Addendum No: 01
Date: February 15, 2024
Owner: Northern Health
Stantec # 144320228

This addendum is to be read with and constitutes part of the tender document.

UHNBC (University Hospital of Northern BC) -
NAPRA Pharmacy Renovation
1475 Edmonton St, Prince George, BC V2M 1S2

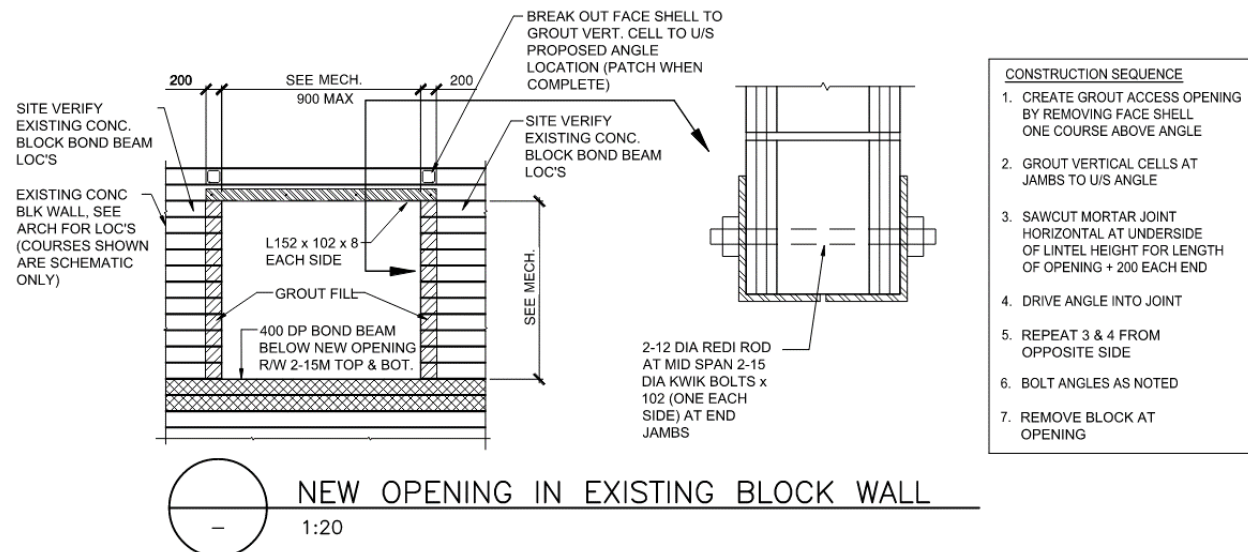
Question: Manufactured Metal Casework

- 1. Due to size and location of “L” shaped worktop on Elev AE201 / 4, worktop will be 2 separate pieces with a mechanical seam. Seam will not be welded. Please confirm.

Answer: Yes, seam not to be welded. No exposed wood in any location, all surfaces need to be 100% cleanable and nonporous as shown on drawings AE302 Millwork details.

Title
**LEVEL 0 - EXISTING AND DEMOLITION
CEILING PLAN**

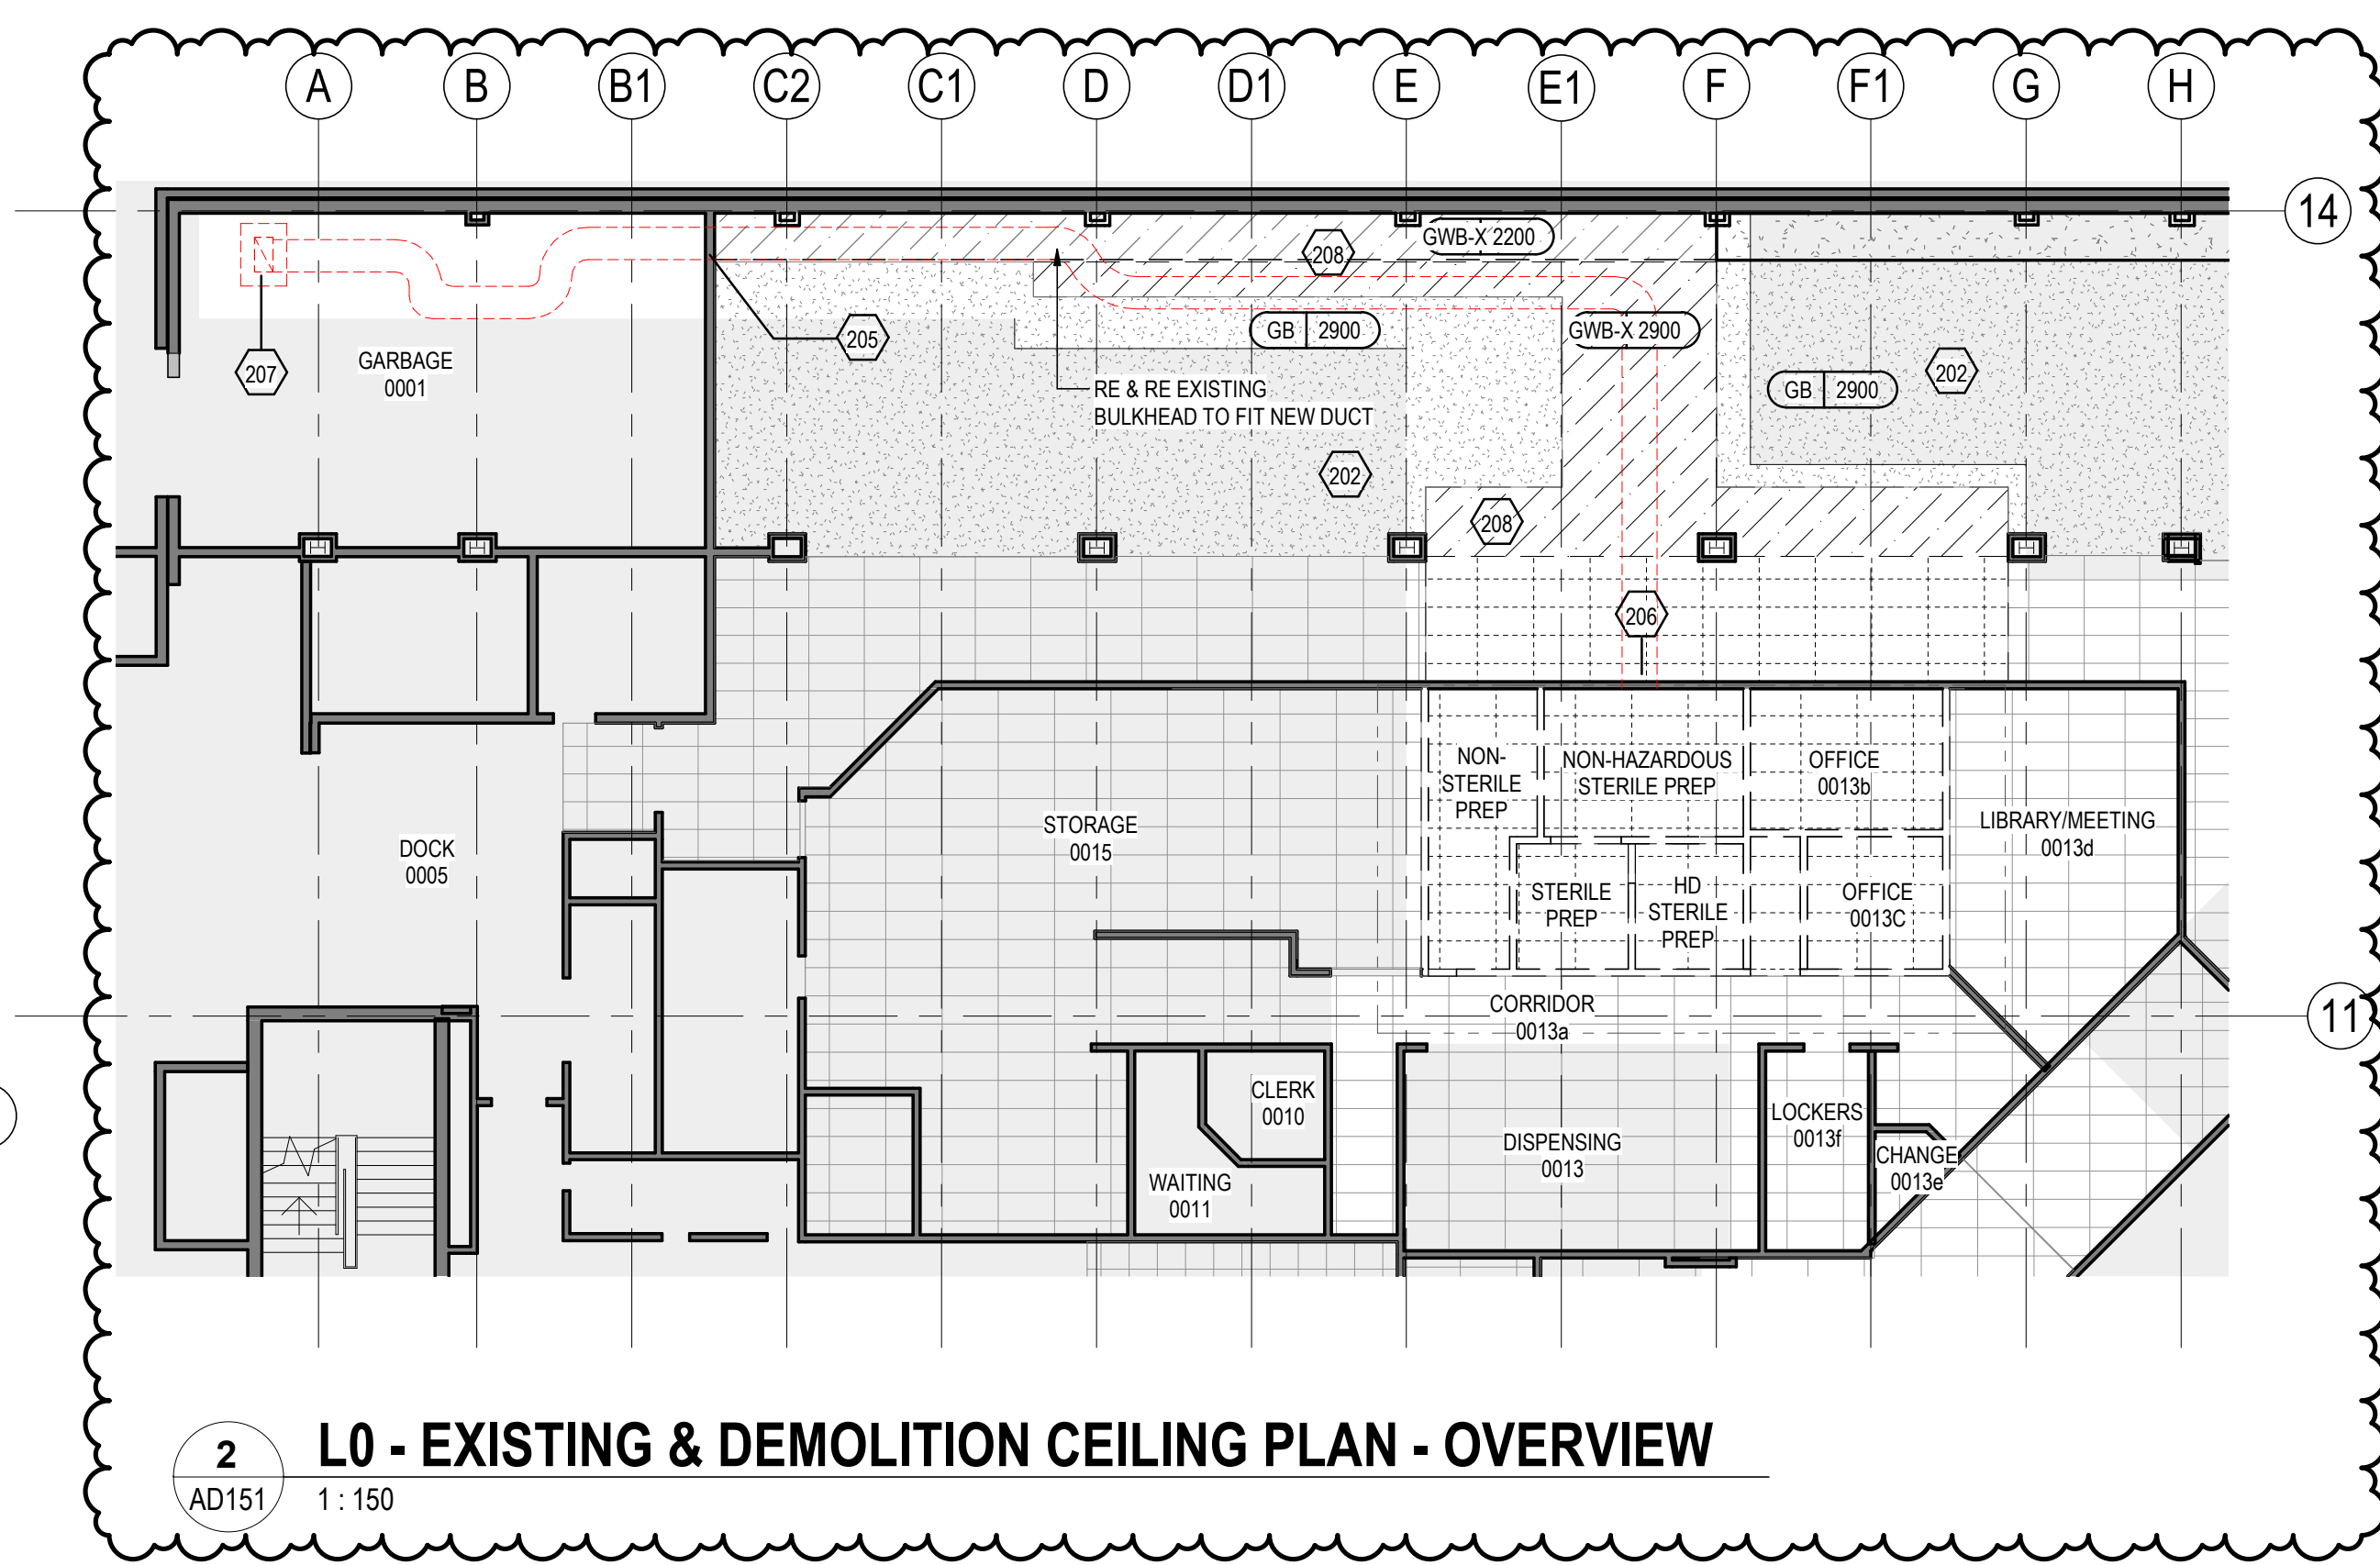
AD151- LEVEL 0 – EXISTING & DEMOLITION CEILING PLAN – OVERVIEW

Drawing 2 updated to show better mechanical route for new duct.

Title
LEVEL 0 - HVAC - OVERVIEW

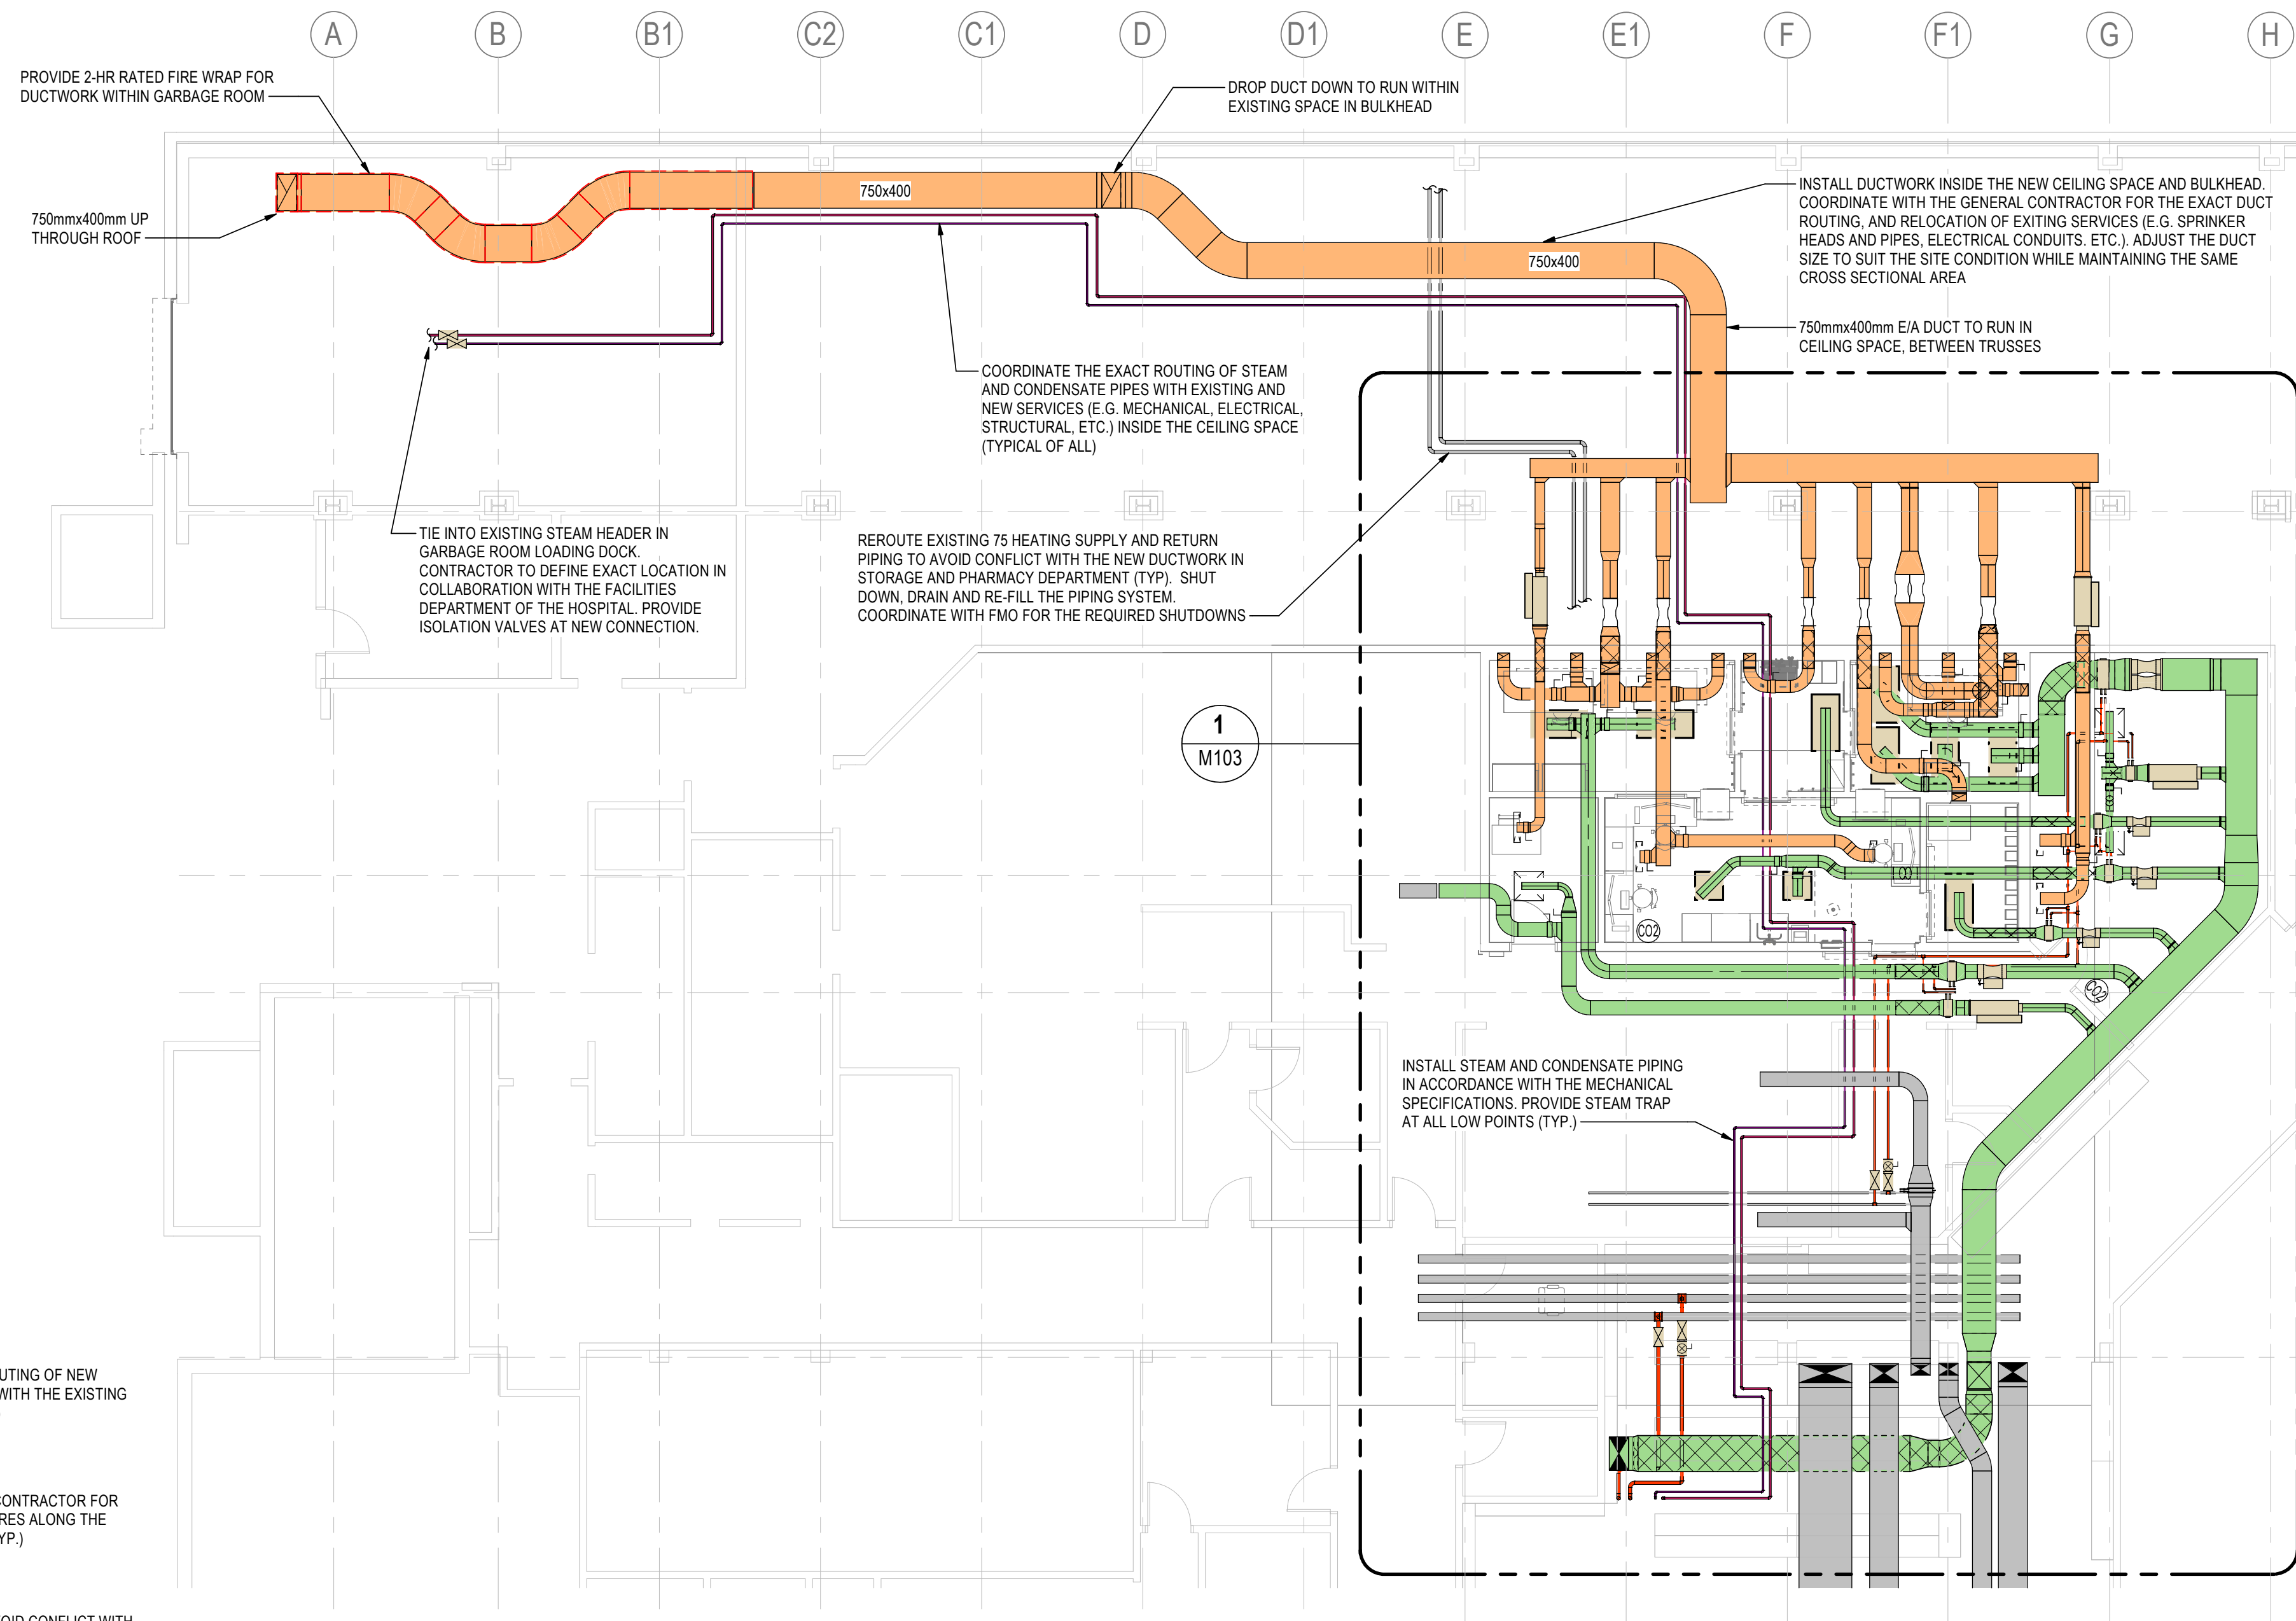
M102 – LEVEL 0 – HVAC – OVERVIEW

Revised EA ductwork routing in Bulk Storage area. Added noting to re & re existing services located in ceiling space.

Revised EA ductwork routing in Garbage Room. Sprinkler piping and heads in Garbage Room to be relocated as necessary.

Added images and notes to provide clarification of EA duct routing and existing services.

Added 2-hr fire wrap for ductwork within garbage room.

Relocate existing lights within the path of the new duct work. Coordinate new locations on site. Extended wiring and conduits as required to the new locations. Refer to the revised drawing M102 for the scope of the new ductwork.
